Re: St. Lucie Plant Unit 2
Docket No. 50-389
Renewed Facility Operating License No. NPF-16

Response to Request for Additional Information Identified During Audit of the Non-Loss
of Coolant Accident Safety Analyses Calculations for the Extended Power Uprate
License Amendment Request

**Response to Request for Additional Information
Identified During Audit of the EPU LAR
Non-Loss of Coolant Accident Safety Analyses Calculations**

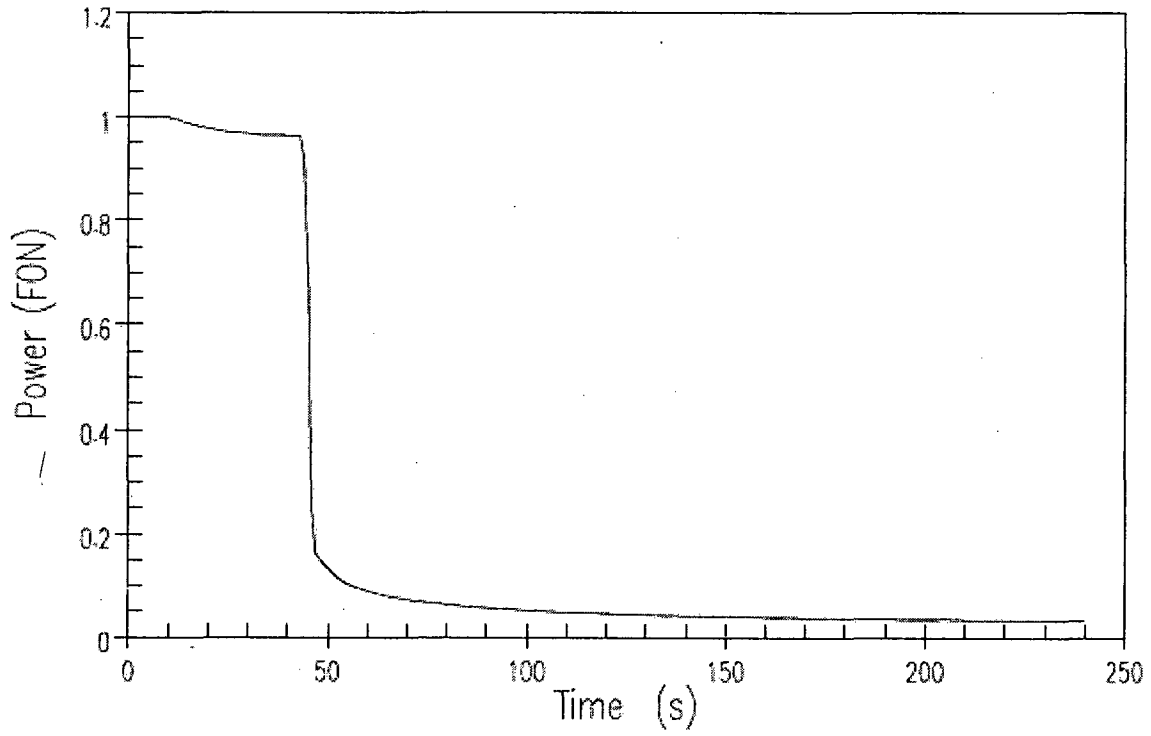
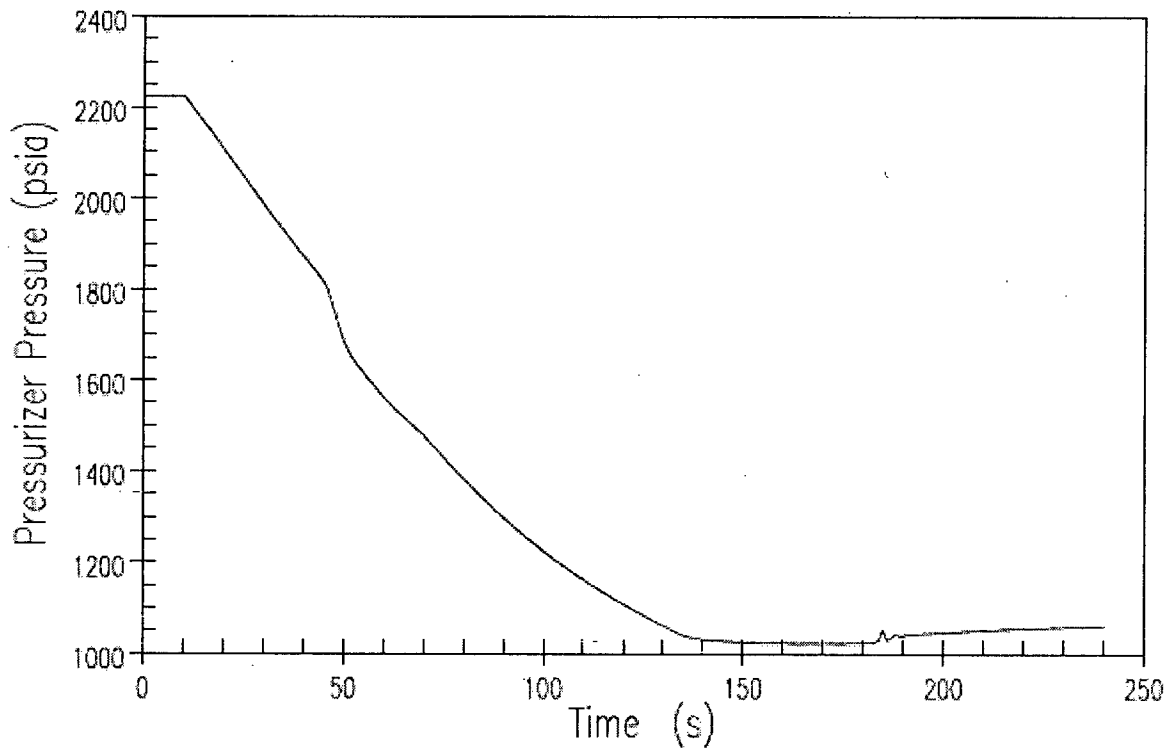
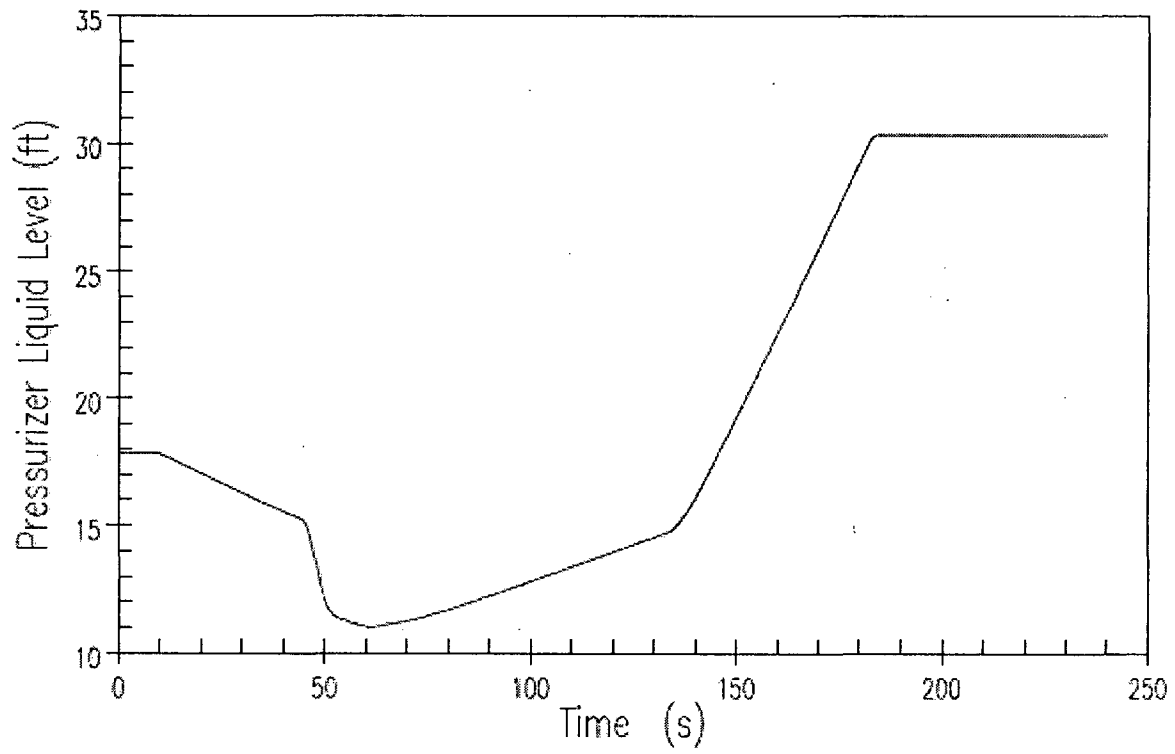
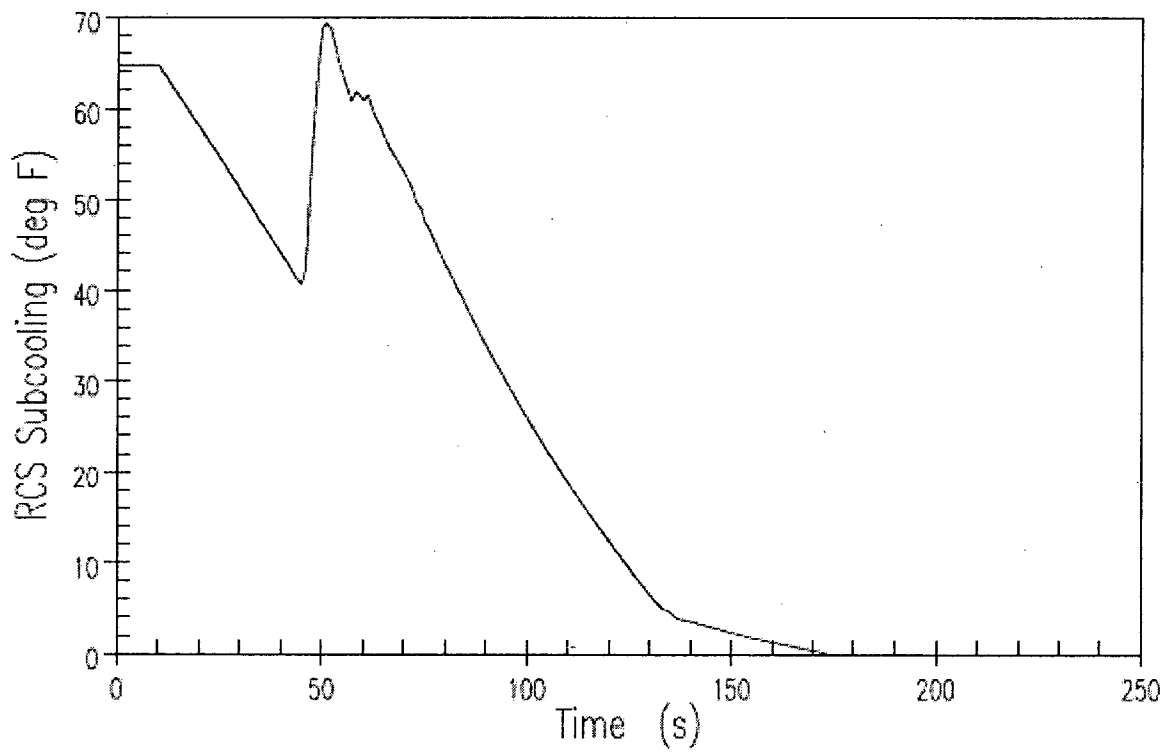
A question was asked with regard to the time required to fill the pressurizer as a result of the IOPORV event. Specifically a question was asked to provide the timing of the pressurizer fill for the IOPORV event and to describe the control room operator's actions used to mitigate the event.

Table IOPORV-2 provides the sequence of events for the IOPORV fill event. The limiting case demonstrates that the pressurizer will fill to a water solid condition in just under three minutes from the start of the event. Figures IOPORV-1 through IOPORV-4 provide additional details of the IOPORV event modeling the overflow condition.
